# ***SAFETY RECALL NOTICE***

**Attention:** Jerr-Dan Dealer  
**Subject:** Sub-Frame Attachment Hardware Replacement  
**Models Affected:** 50 Ton - Heavy Duty Wrecker  
**Date:** January 31, 2013  
**Reference Number:** 12V-598

**PROCEDURE:** Mid Saddle Sub-Frame Hardware Replacement Procedure  
**MODELS:** Jerr-Dan Heavy Duty Wrecker, Model 50 Ton Independent

**PROCEDURE:** Front Saddle Sub-Frame Hardware Replacement Procedure  
**MODELS:** Jerr-Dan Heavy Duty Wrecker, Model 50 Ton Integrated

**Figure #1 – New Hardware Locations**  
Mid-Saddle - Left Side of Truck

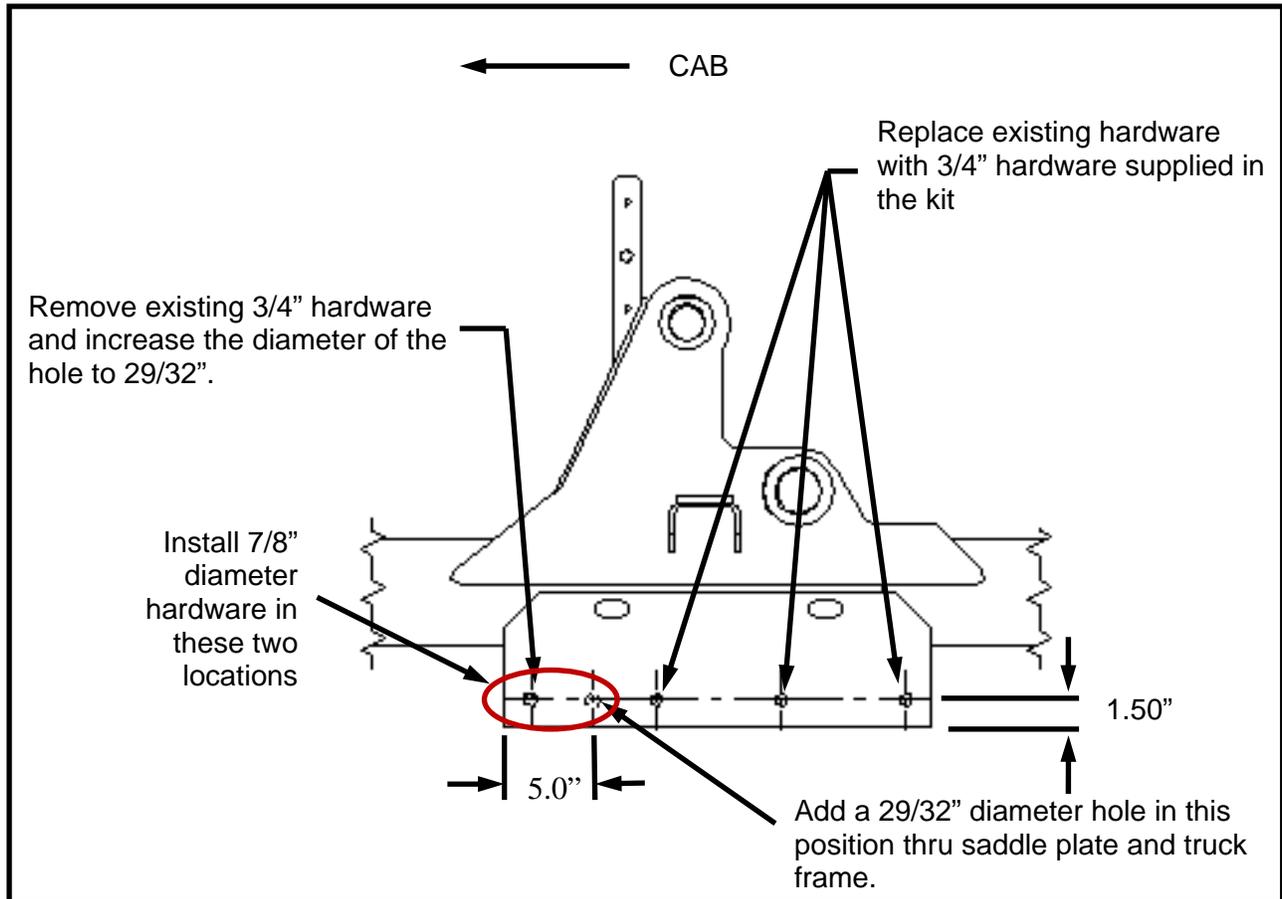
1. Utilizing drilling equipment, add the new 29/32" diameter mounting hole and hardware to left mid-saddle according to Figure #1.
  - a. **Note: Do not torque hardware at this point.**
2. Remove the front 3/4" diameter existing hardware from the left side mid-saddle. Discard the hardware to prevent reuse.
3. Utilizing drilling equipment, increase the front 3/4" diameter hole to 29/32" diameter hole. Install 7/8" hardware provided in the kit in this location.
  - a. **Note: Do not torque hardware at this point.**

4. Replace existing 3/4" diameter hardware with new 3/4" diameter hardware provided in the kit. Discard the removed hardware to prevent reuse.
5. Torque hardware in Figure # 1
  - 3/4" diameter hardware to 400 lb/ft
  - 7/8" hardware to 600 lb/ft.

Figure #2 – New Hardware Locations  
Mid-Saddle - Right Side of Truck

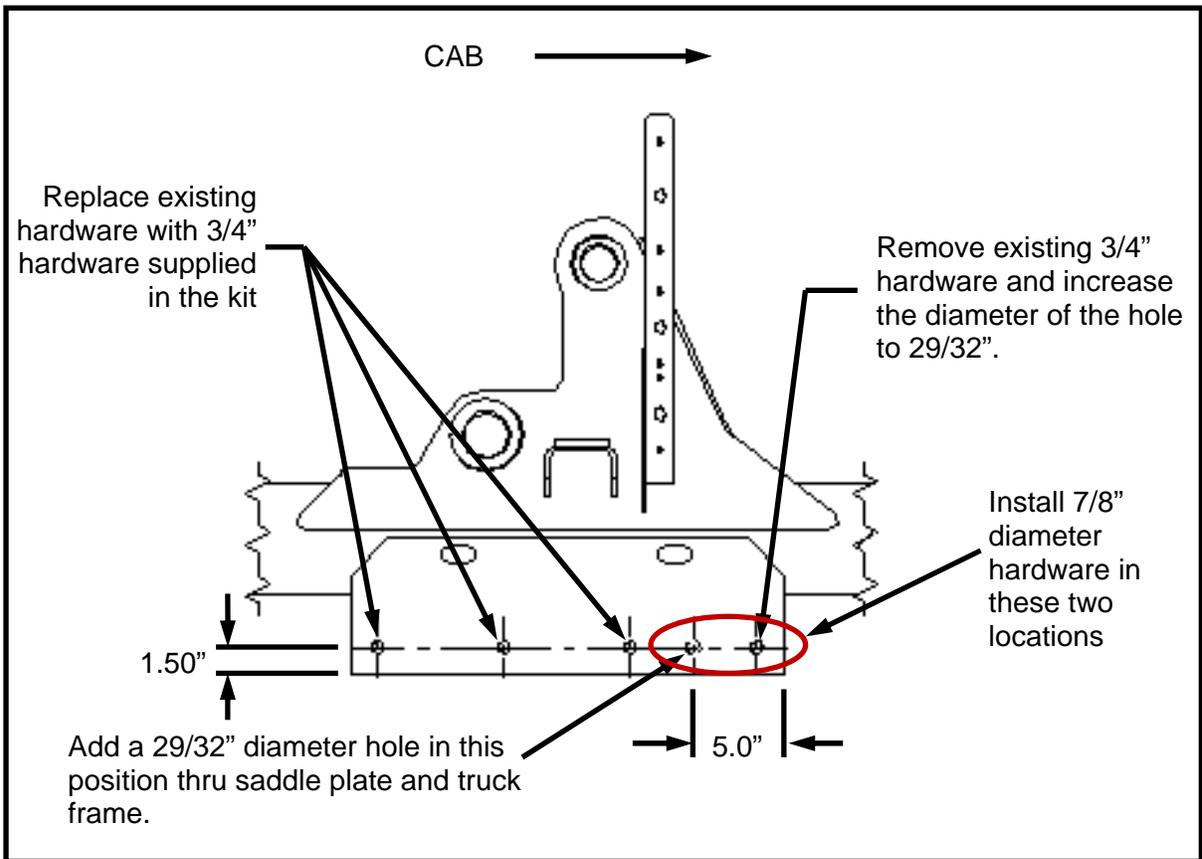
1. Repeat the same procedure as performed on the left side mid-saddle hardware change above, except to reference Figure #2 for the right side.

**Figure #1 – New Hardware Locations  
Left Side of Truck**

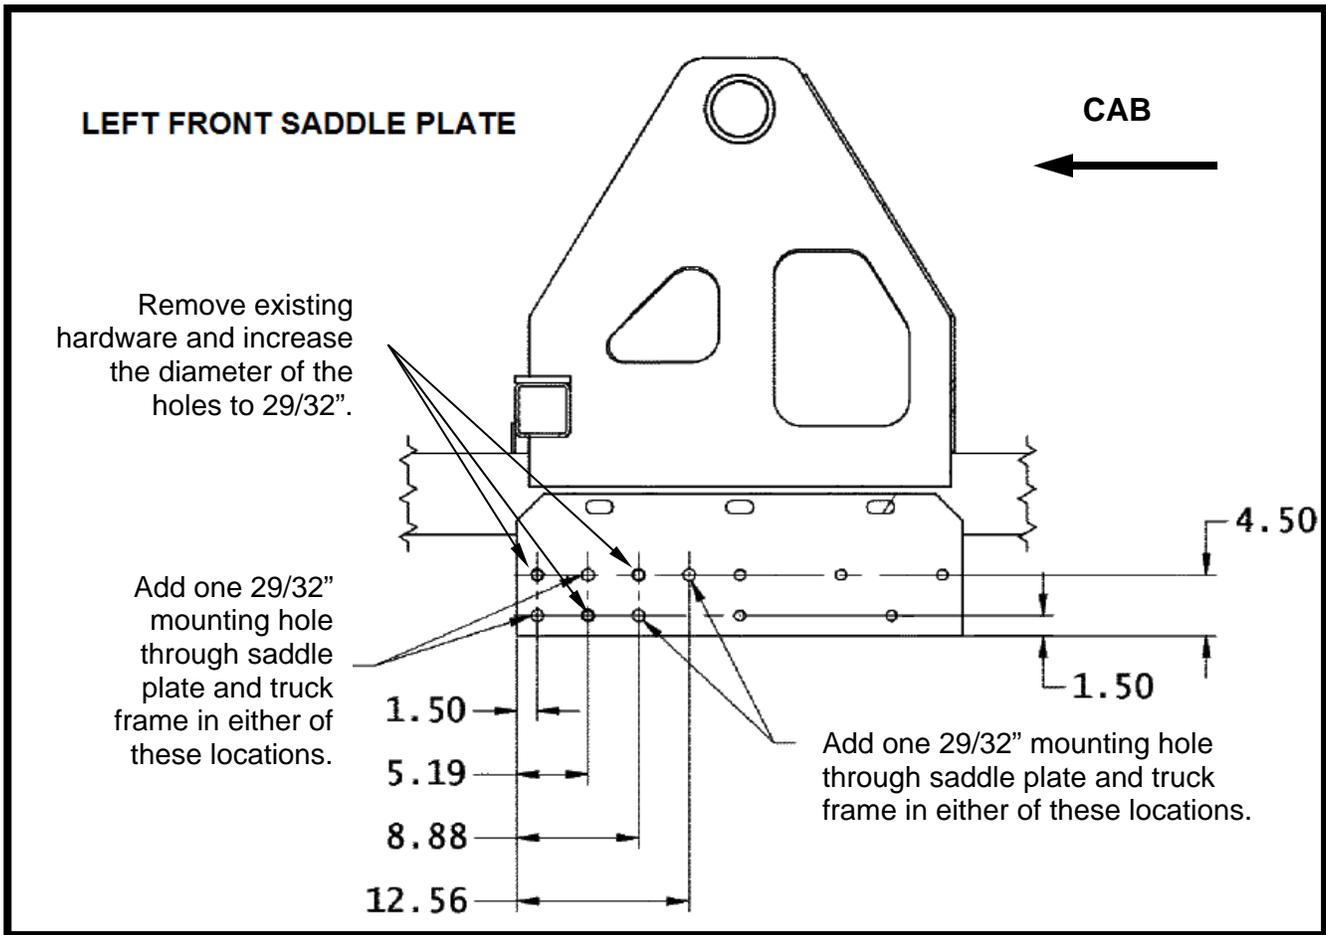
4. Reference Figures #1 and #2 and
  - a) Utilizing drilling equipment, add two new mounting holes and hardware to both the left and right front saddles
  - b) Remove the existing 3/4" hardware in the front 3 locations and increase the hole diameter to 29/32". Only the front 3 locations.

c) Install 7/8" hardware in these new and existing holes.

**Note: Do not torque hardware at this point.**

**Figure #3 – Hardware Inspection and Replacement  
Left Side of Truck**

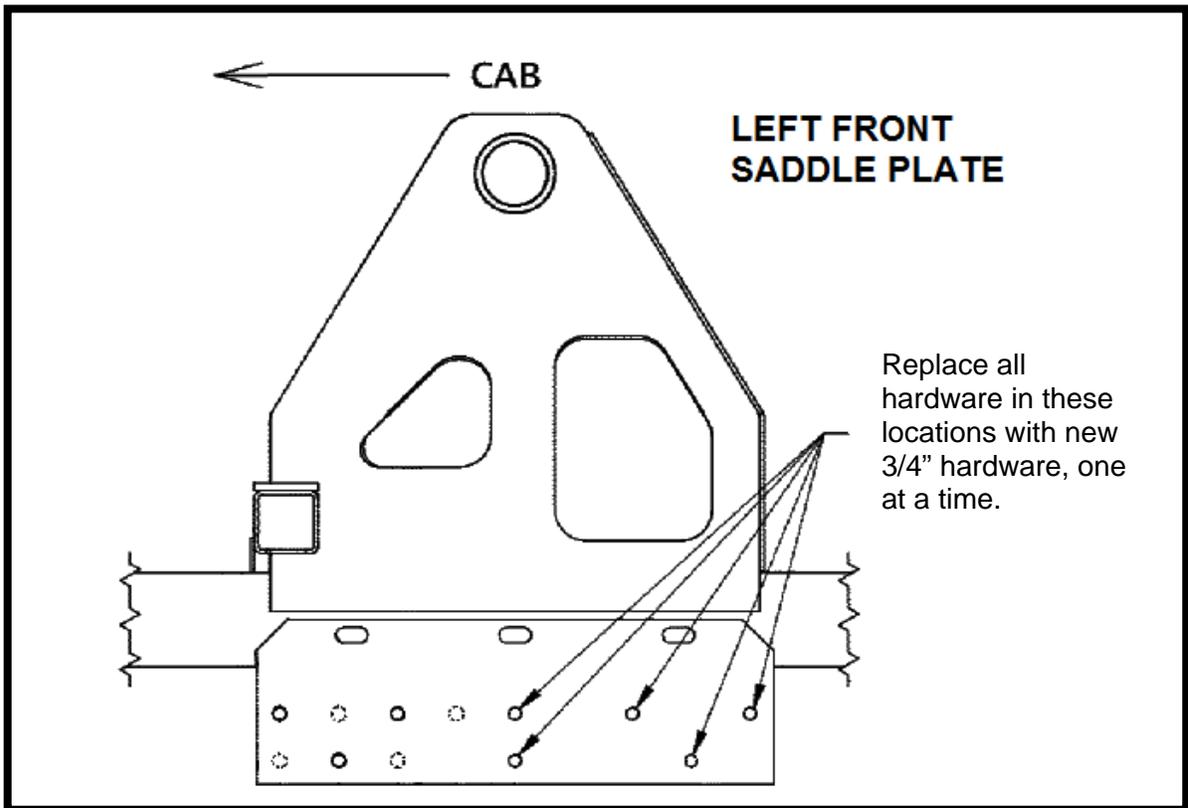
- 5. Remove and replace bolts indicated in Figure #3 and Figure #4 with new 3/4" hardware, one bolt at a time. Do not torque hardware.

Figure #7 – Torque Pattern  
Left Side of Truck

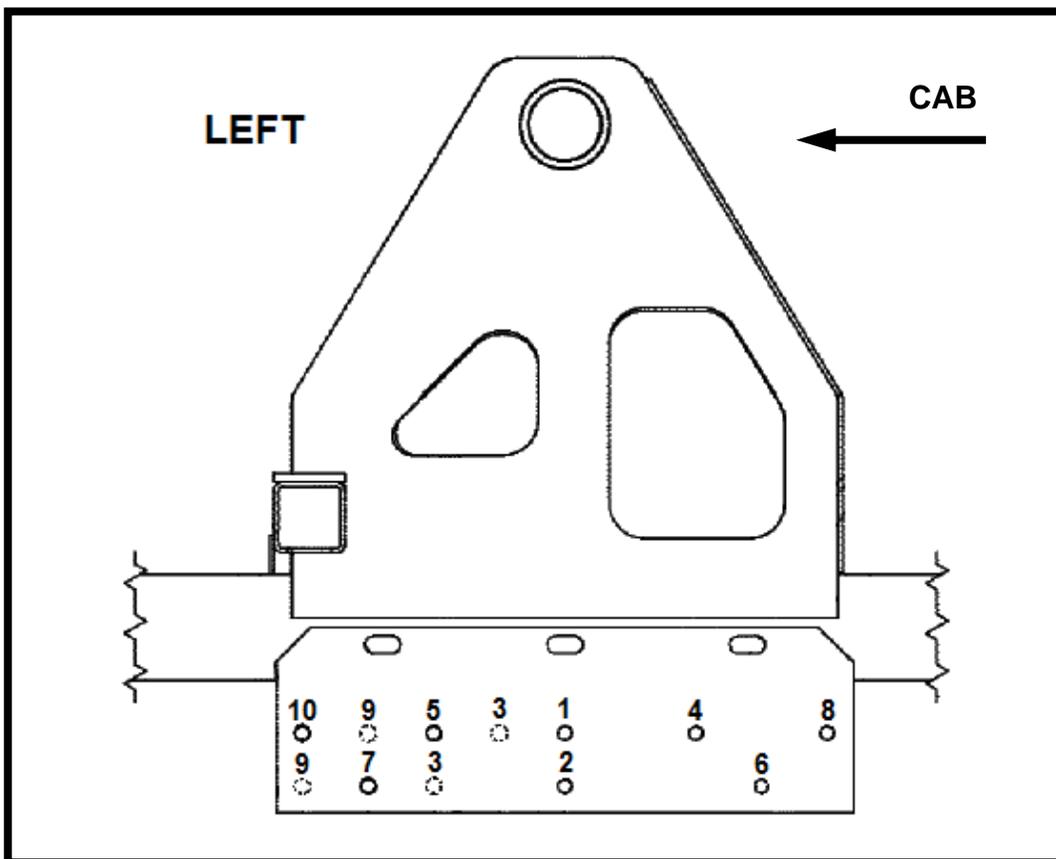
- 6. Torque hardware in the order indicated in Figure #7 and Figure #8. Torque 3/4" hardware to 400 lb/ft and 7/8" hardware to 600 lb/ft.
